PLANNING COMMISSION STAFF REPORT AGENDA ITEM NO. E3 June 20, 2006

Request for a Planned Development Permit, Tentative Parcel Map and Architectural Review Permit to construct 350 residential units with common space and below grade parking on Lots three and four of the Crossing for the purpose of developing this site in conformance with the adopted U.S. Navy Site Specific Plan, per Chapters 12.96.190 and 12.108.010(A) of the San Bruno Municipal Code. SNK SB Crossing, LLC, Applicant/Owner. **PDP-05-05, TM-06-003, AR-06-04**

Crossing: Parcels 3 & 4, 350 housing units

Summary of Larry Cannon's Comments. The applicant's revisions in response to these comments are noted in italics.

THE CROSSINGS PHASE 3 & 4 Garage Comments San Bruno

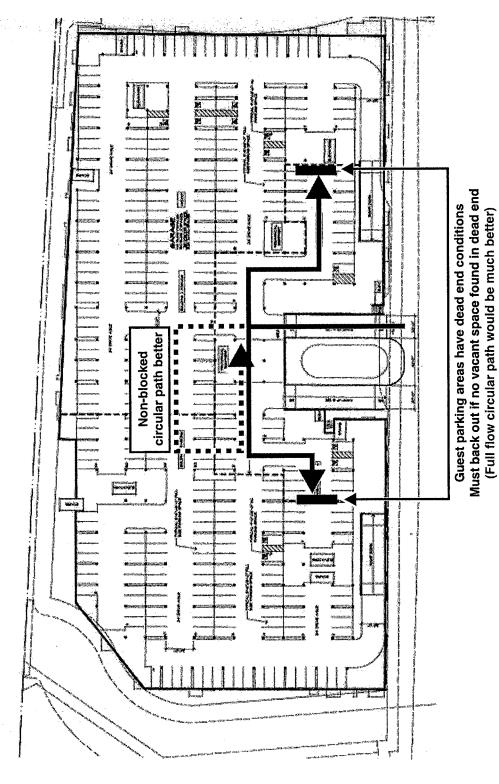
- Consider finding another less prominent location for the garage entry, entry fountain is isolated by garage ramps on each side. Edges at entry fountain seem very abrupt. Rather than change the entry location to the parking garage, the applicant consolidated the two access ramps into one 24' wide access ramp and added another access ramp at the rear of the site. The applicant redesigned the water element at the top of the access ramp and at either side of the ramp.

National Avenue Elevation Comments THE CROSSINGS PHASE 3 & 4 San Bruno

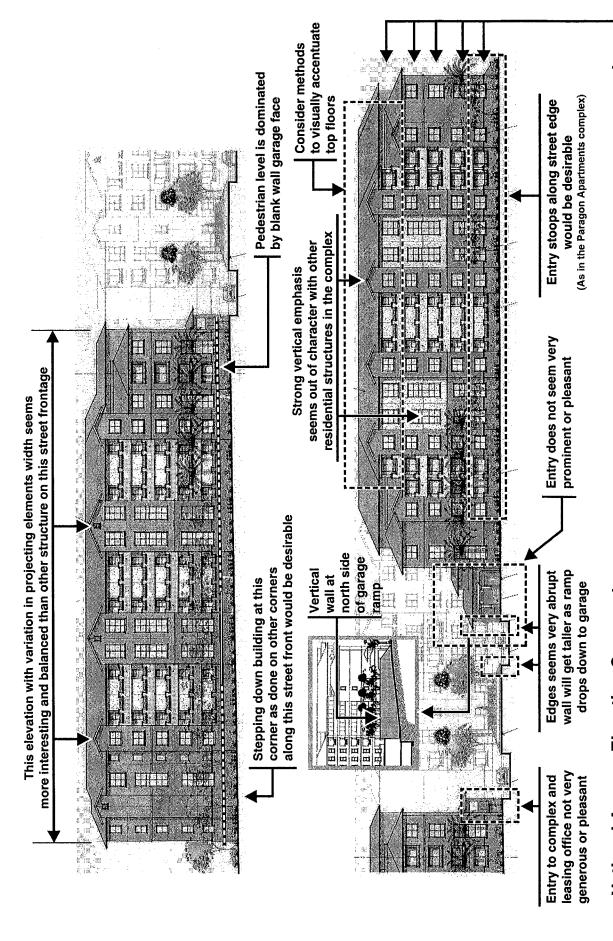
- (Building one) Stepping down building at this corner as done on other corners along this street front would be desirable. Pedestrian level is dominated by blank wall garage face. The applicant added awnings to the top floor windows and vertical siding to the upper floors. The applicant increased the height of the planting berm.

Same general treatment of windows and balconies on all

floors not very interesting (Especially on tall thin elements)

Commodore Drive Elevation Comments THE CROSSINGS PHASE 3 & 4 San Bruno

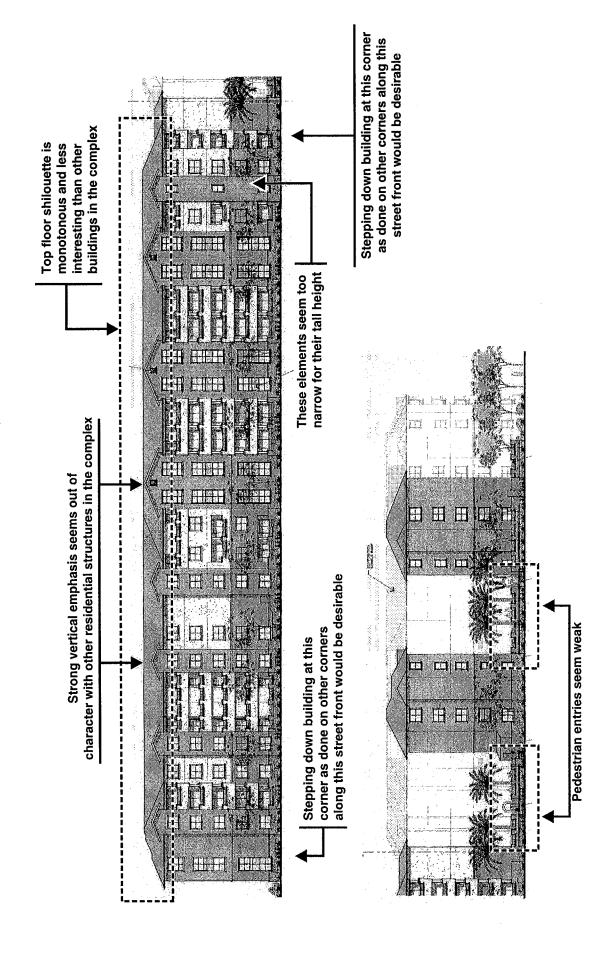
- (Building two) Strong vertical emphasis seems out of character with other residential structures in the complex. Consider methods to visually accentuate top floors. Same general treatment of windows and balconies on all floors not very interesting (especially on tall thin elements), entry stoops along street edge would be desirable. The applicant added awnings to the windows of the upper floors and added horizontal siding at a portion of the top two floors. The applicant also incorporated entry stoops and increased the height of the ground level planting berm. The applicant also modified the upper level balconies and the roof detail at the center of this building to provide more visual interest.

Alternative Elevation Approach THE CROSSINGS PHASE 3 & 4 San Bruno

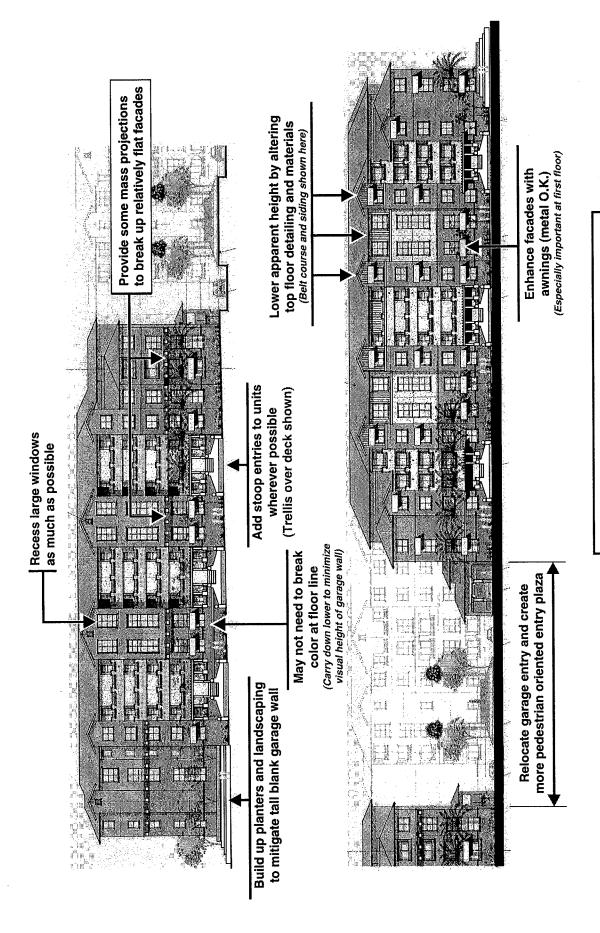
Note: These are not intended as complete elevations. Rather, they are techniques that could be explored to add variety and visual richness to the design.
